Central Carolina
Soil Consulting
919-784-9449
Project # 273

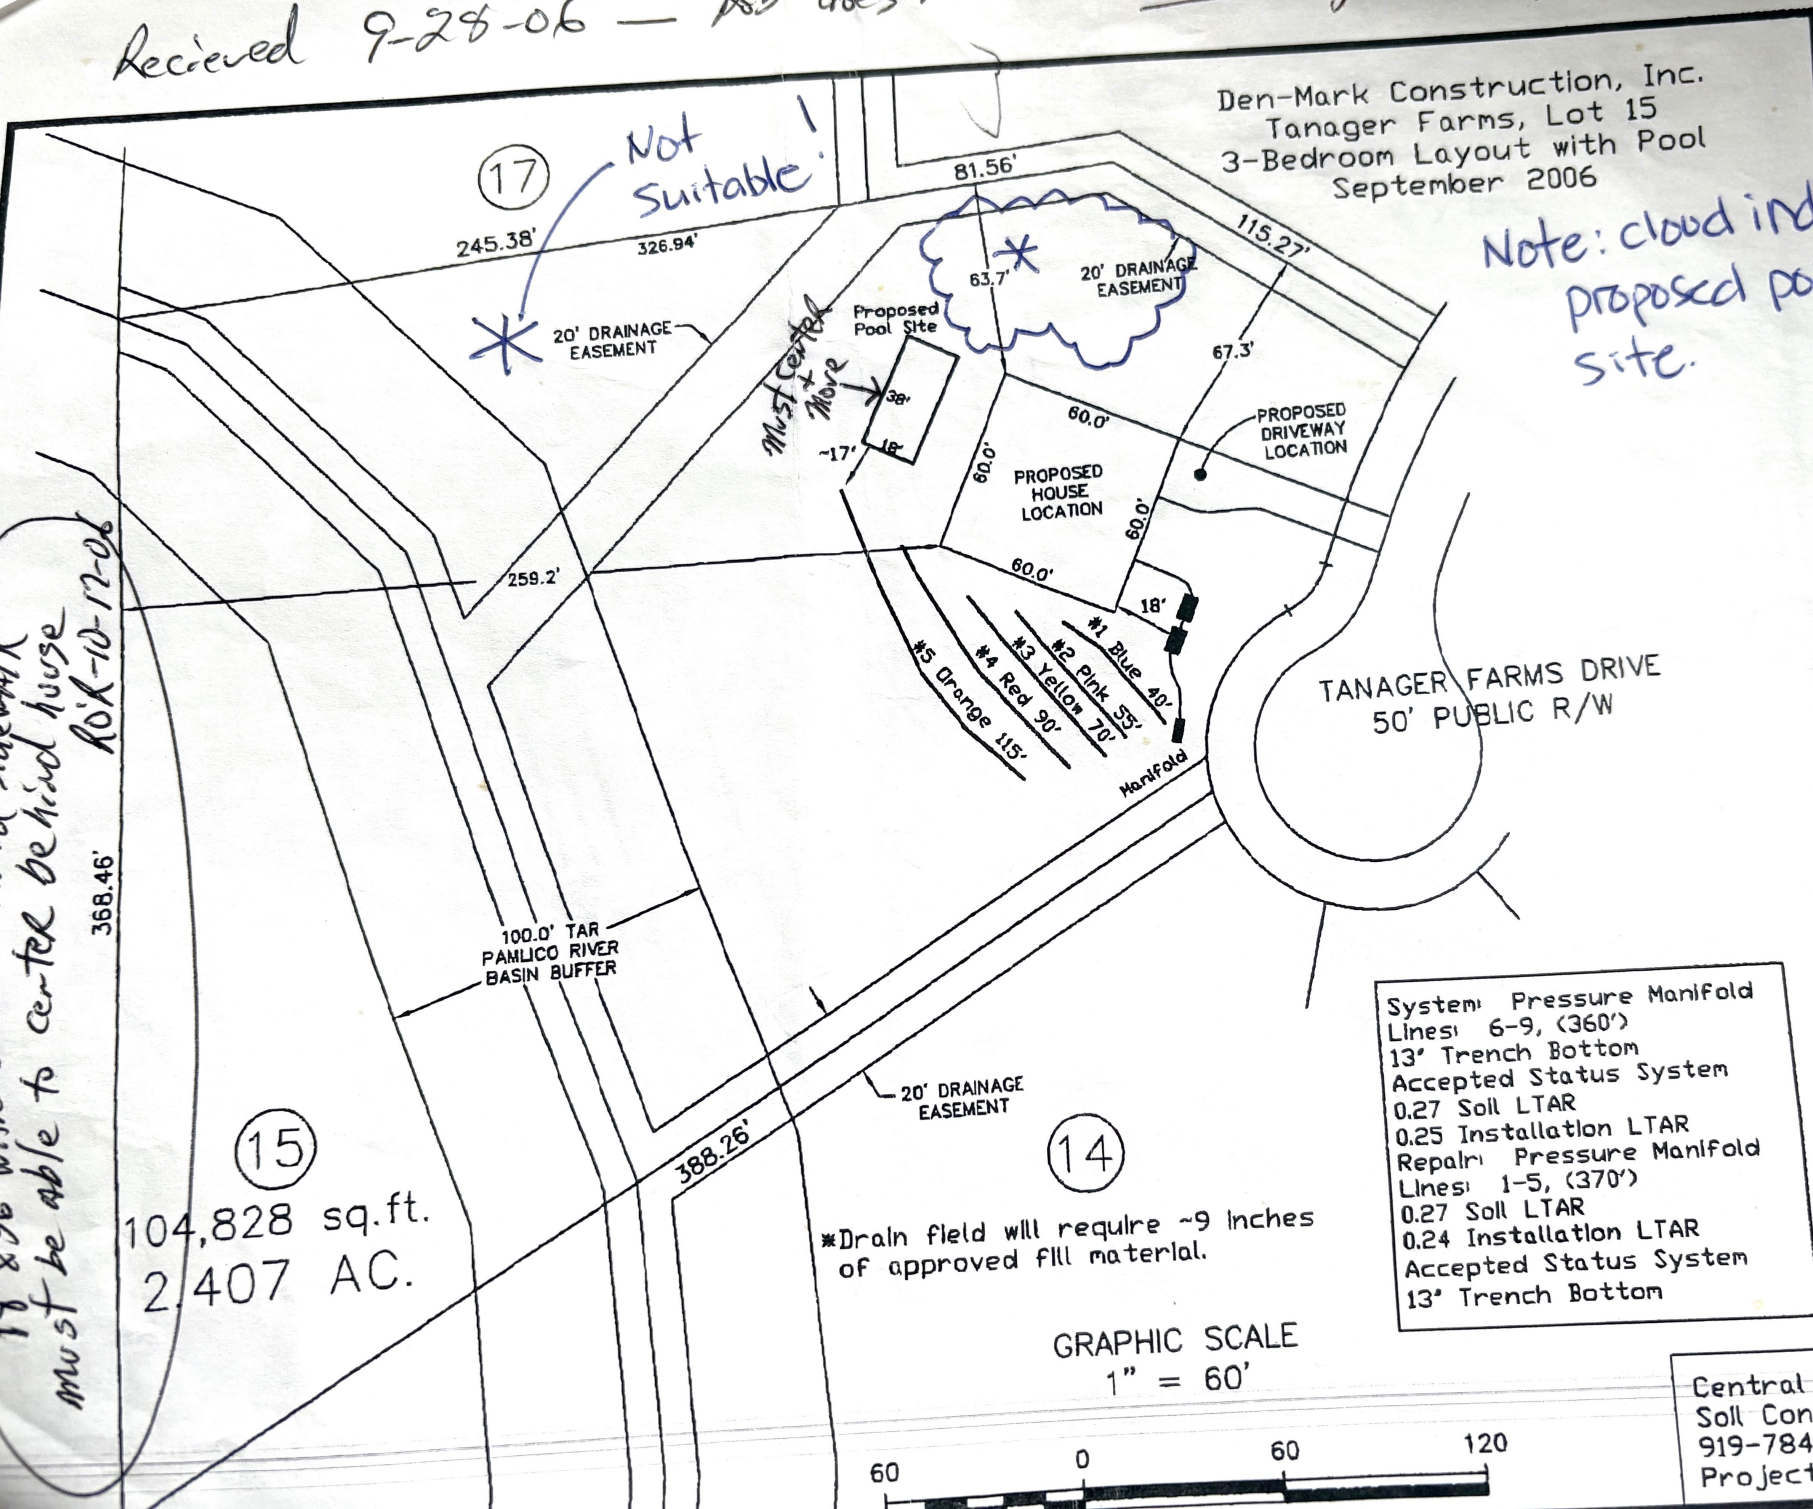
Received 9-28-06 — Ab does not like it. Rejected Proposal = #2

18' x 36' with 6" foot sidewalk
must be able to center behind house
R.O.K. 10-12-06
